BULLETIN #212

W19, W55 AND W56

CREEP SPEED MALFUNCTION

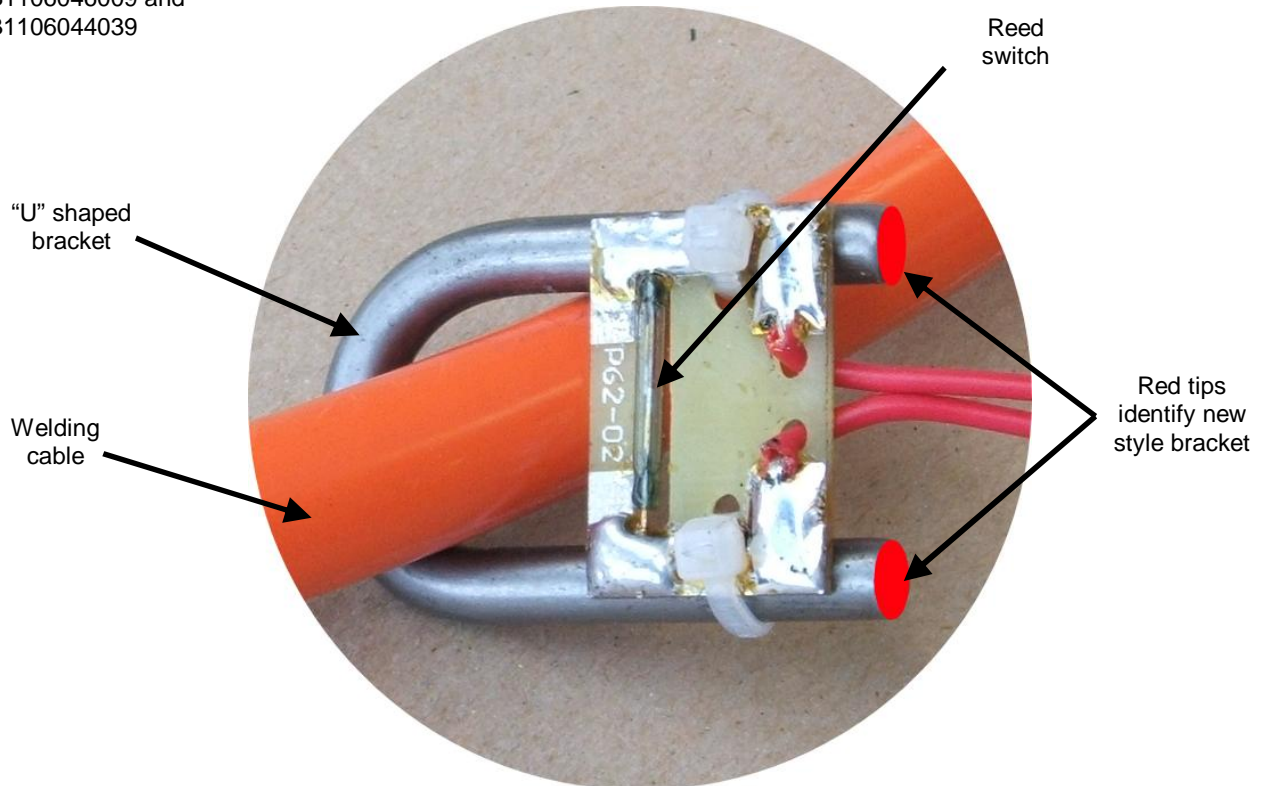
When "Creep Mode" is selected, the W19, W55 and W56 wirefeeders use a current sensor to detect welding current, initiating an increase in the wire speed to the desired wire speed. The current sensor has a "U" shaped mild steel bracket which magnetically closes the contacts of a reed switch when weld current flows through the welding cable.

There have been some cases where the "U" shaped bracket which is part of this current sensor can suffer from residual magnetism and continue to hold closed the reed switch even after weld current has stopped.

We have changed the material specification for the "U" shaped bracket to ensure that the reed switch reliably opens immediately welding ceases.

The new bracket can be identified by red marking on the tips of the bracket, and has been used in wirefeeders manufactured after the following serial numbers.

W193A1106011008,
W550B1106046009 and
W560B1106044039

If a customer reports that the wire speed doesn't start off slowly when Creep Mode is selected (on a wirefeeder before above serial numbers), it is likely that the bracket is holding in the reed switch for too long. Please contact the WIA Technical Service Coordinator for a replacement new style bracket.
